# Project T10/1559-D

## Information technology - SCSI Enclosure Services - 2 (SES-2)

# Summary of Comments on SCSI Enclosure Services - 2 (SES-2)

Figure 2 — Standalone enclosure services process

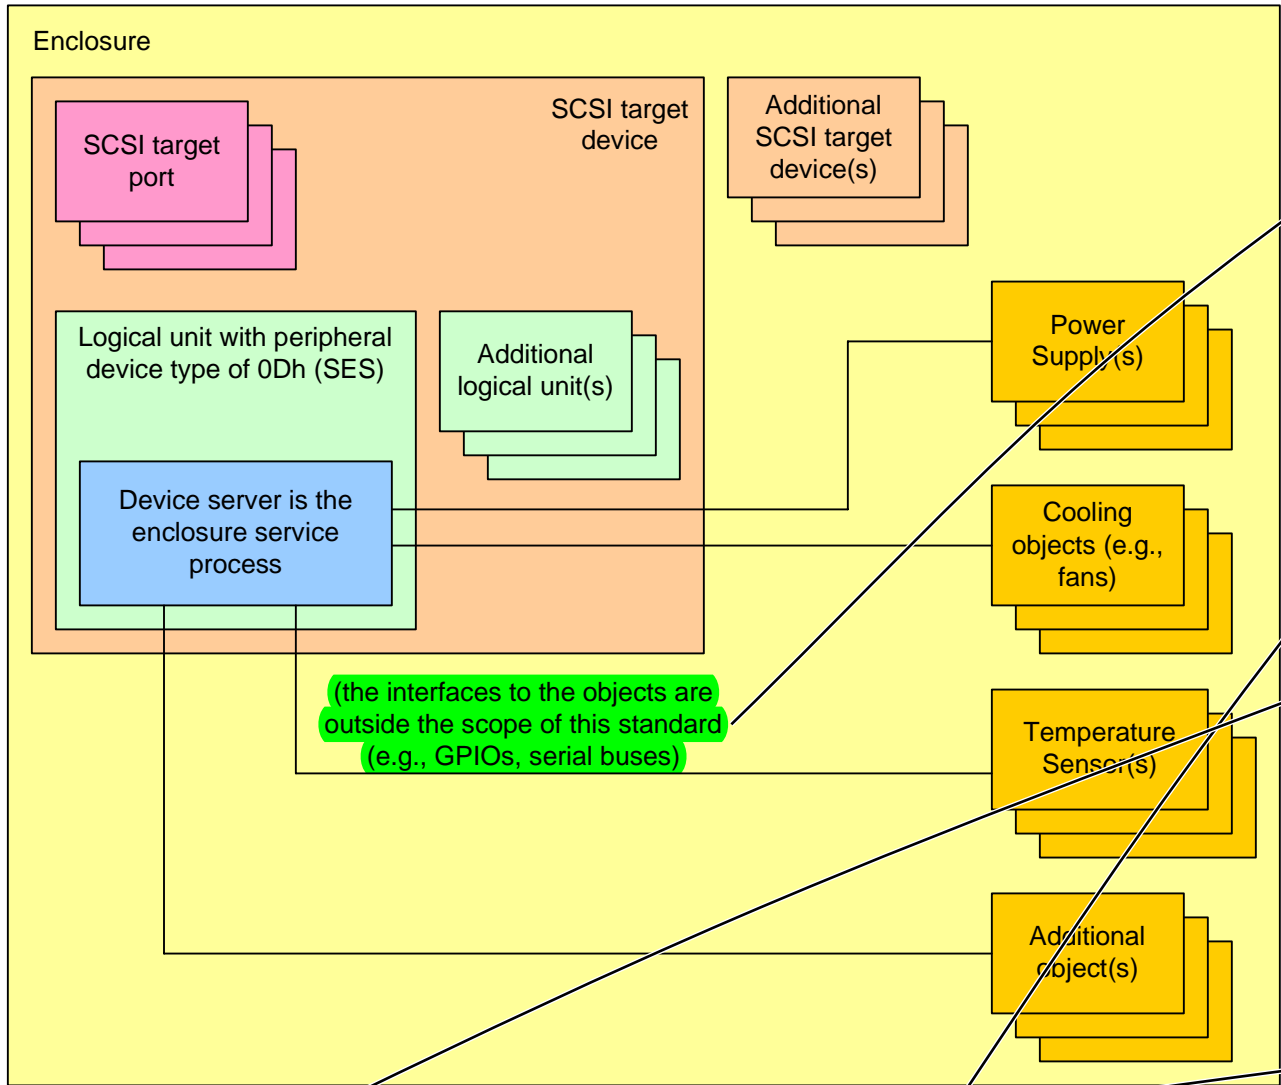
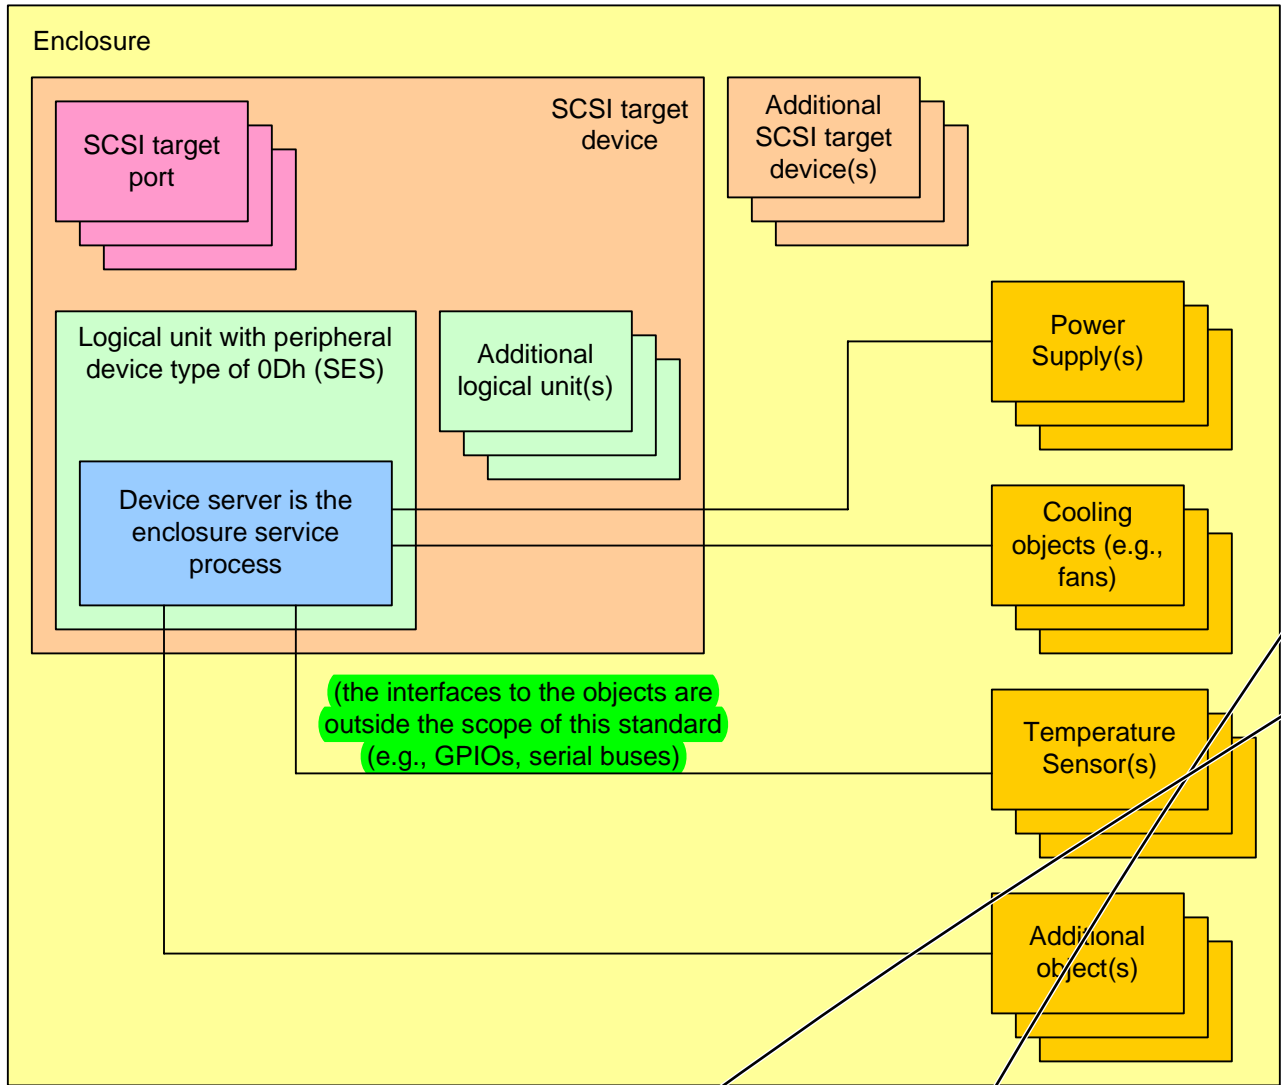
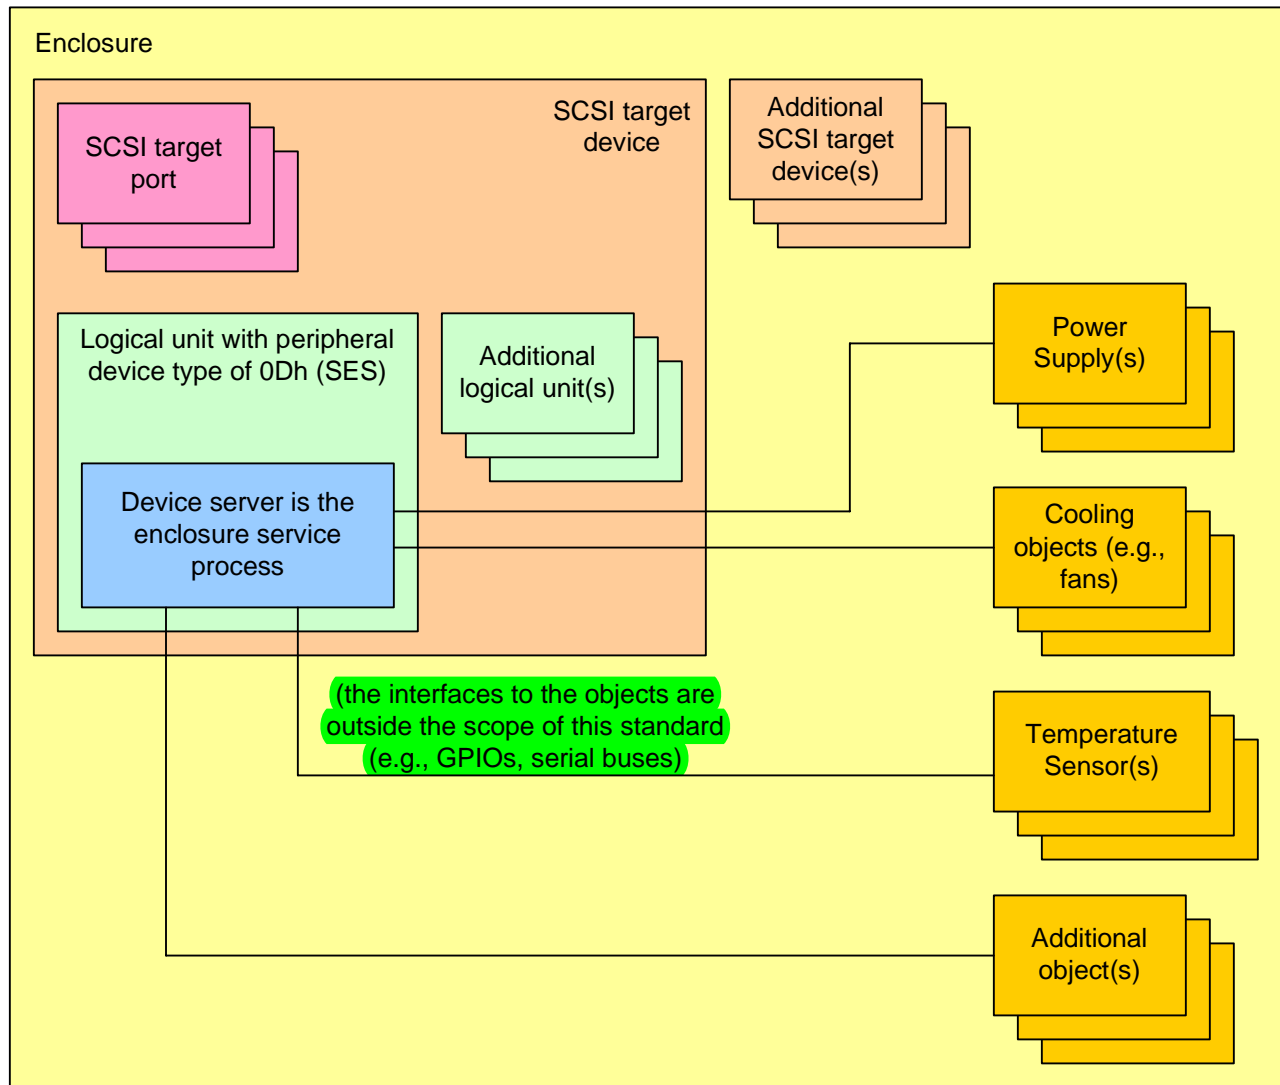
figure 2  
This << (the interfaces to the objects are outside the scope of this standard (e.g., GPIOs, serial buses) >> should be << (the interface protocols used are outside the scope of this standard (e.g., GPIOs, serial buses)) >> note missing << ) >>

Author: relliott  
Subject: Note  
Date: 3/19/2008 1:43:07 PM  
added "instead" after the ;, but left the ; in place. The sentences are closely related.

Figure 3 — Attached enclosure services process

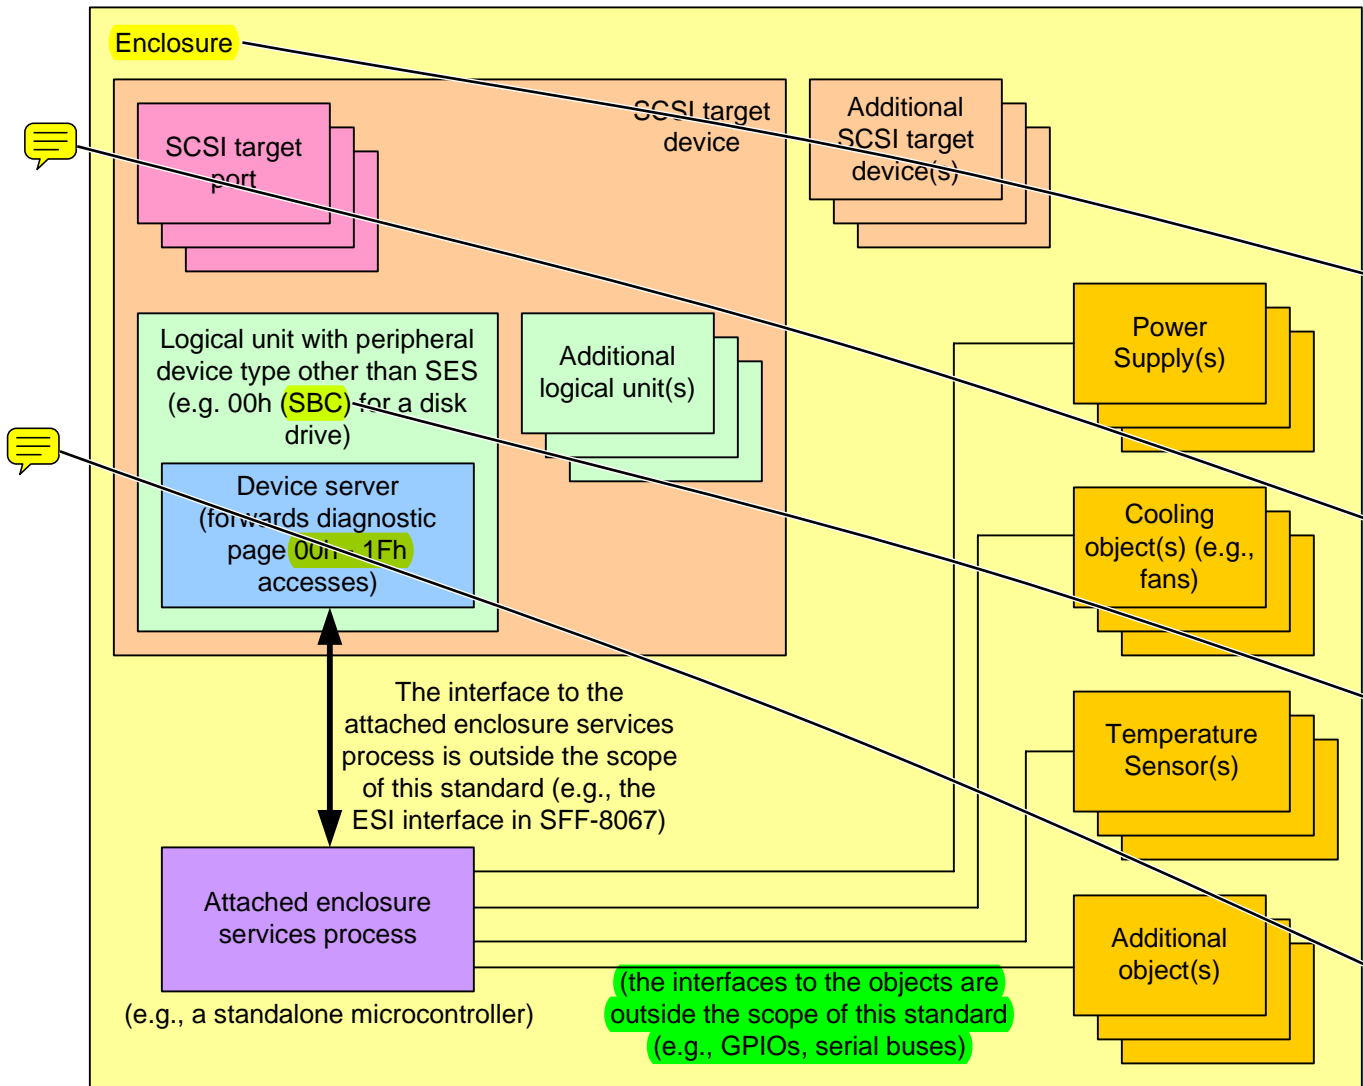
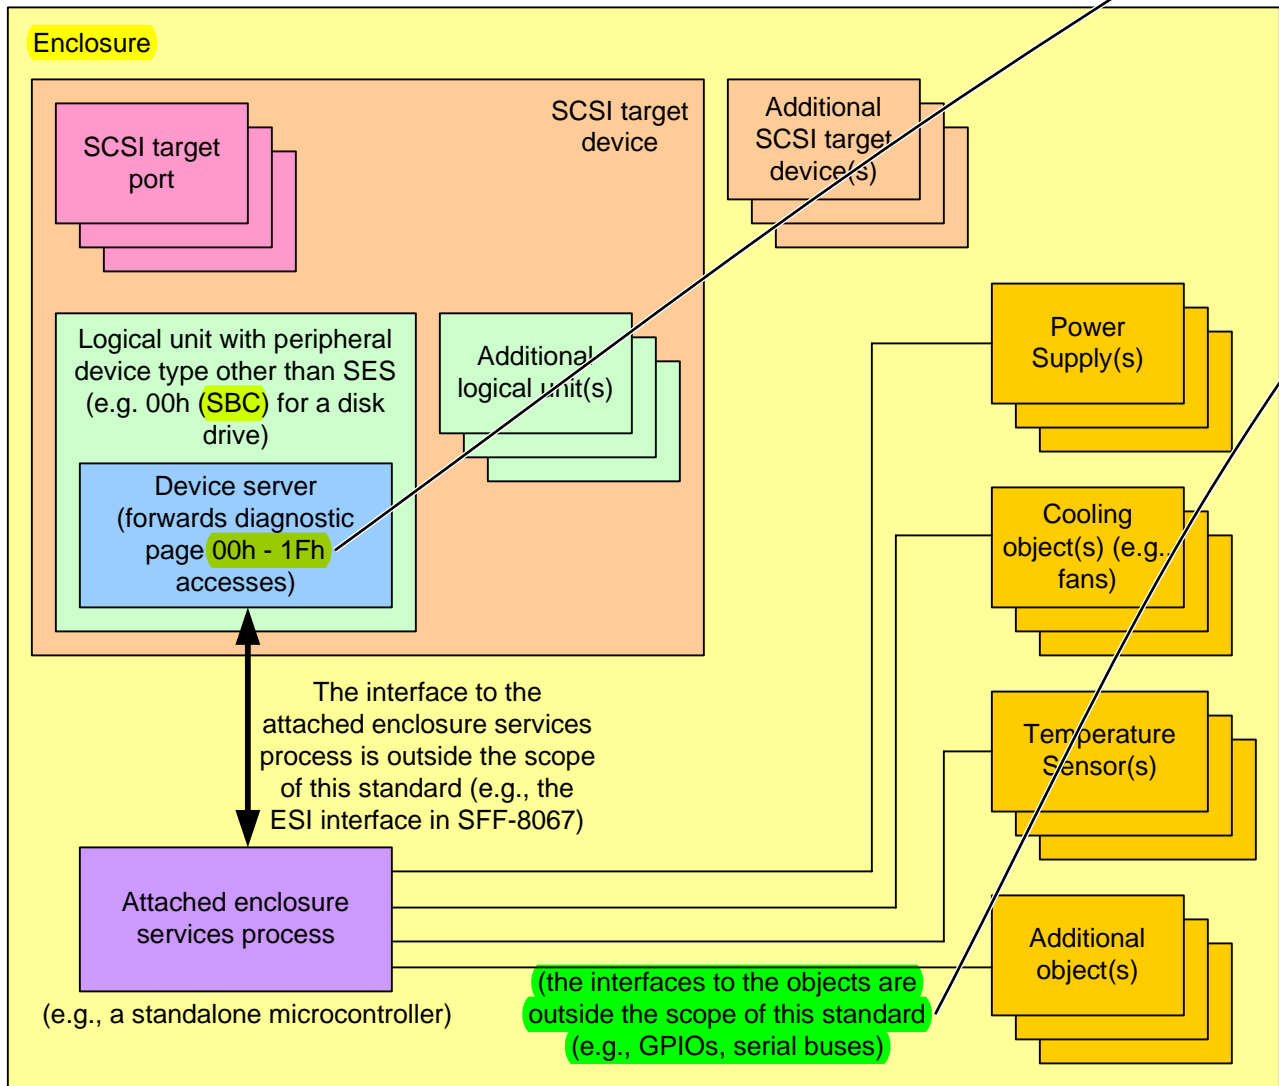
● Author: symc-roger  
Subject: Note  
Date: 12/13/2007 8:25:13 PM -06'00'  
 SYMANTEC 11  
PDF pg 28, pg 10, Figure 3

T Figure 3  
figure 2

● Author: relliott  
Subject: Note  
Date: 5/12/2008 3:36:09 PM  
 Show the enclosure boundary not wholly containing the SCSI target device

**Figure 4 — Subenclosures**

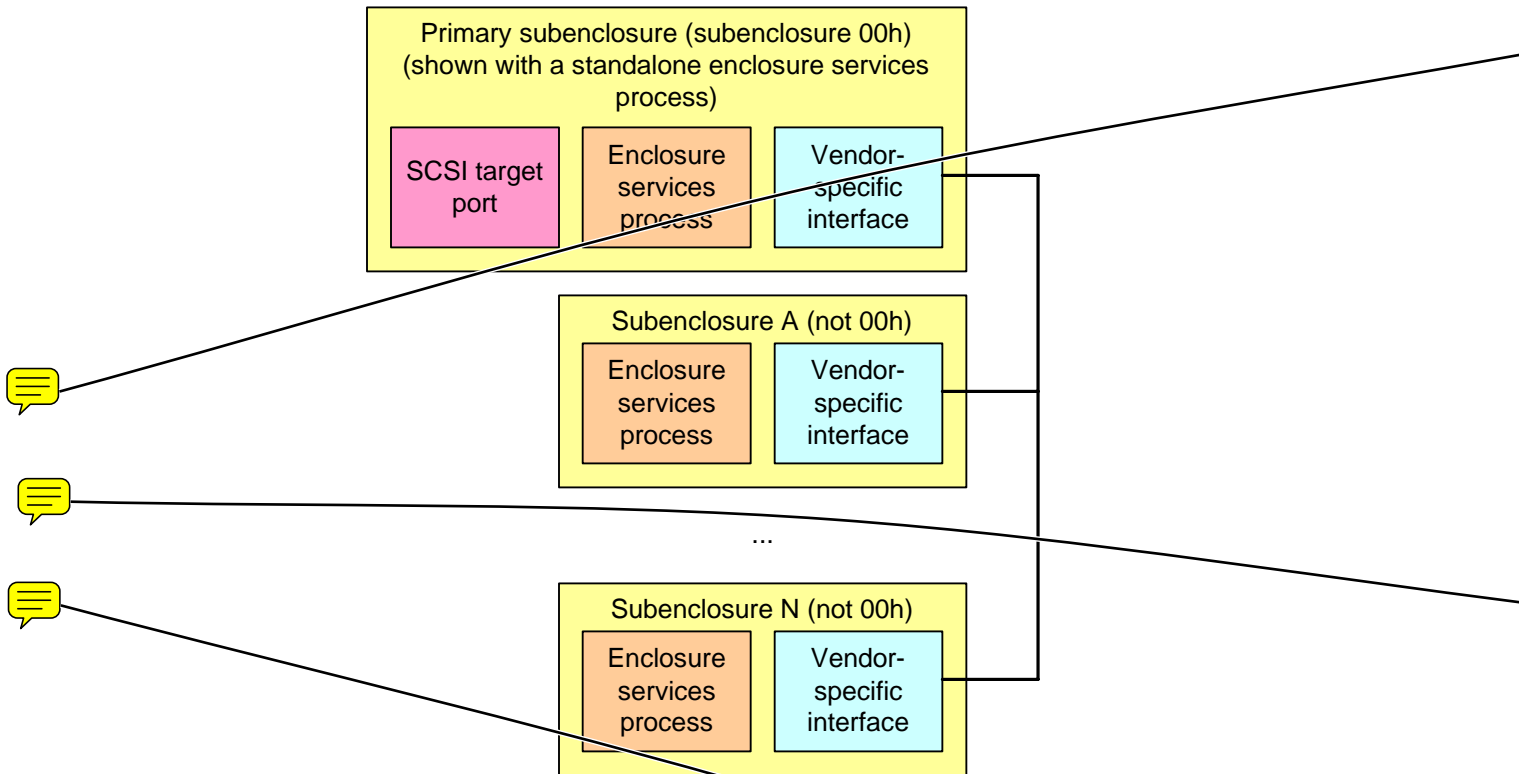
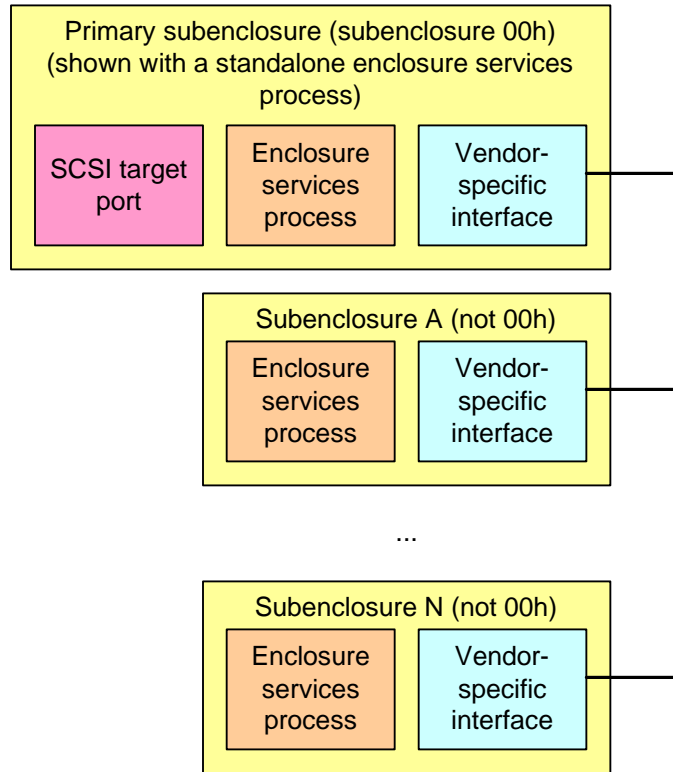
● Author: symc-roger  
Subject: Note  
Date: 12/13/2007 8:25:13 PM -06'00'  
 SYMANTEC 18  
PDF pg 31, pg 13, Figure 4

The enclosure descriptor of the configuration diagnostic page supports multiple enclosure service processes per subenclosure, and this should be reflected in the figure.

● Author: symc-roger  
Subject: Note  
Date: 12/13/2007 8:25:13 PM -06'00'  
 SYMANTEC 19  
PDF pg 31, pg 13, Figure 4

The figure is the only place that indicates that the subenclosure identifier of the primary subenclosure should be 00h.

Also, added a Enclosure box to the figure surrounding all the subenclosures.

added new section and new figure showing that. It's too complicated to overlay that with multiple subenclosures (which would then demand that standalone/attached be included as well).

Prepend the following sentence to the second paragraph after the figure: "The subenclosure identifier of the primary subenclosure shall be 00h."

● Author: relliott  
Subject: Cross-Out  
Date: 5/12/2008 3:36:09 PM  
 Delete this, replaced by simpler text and an improved figure:
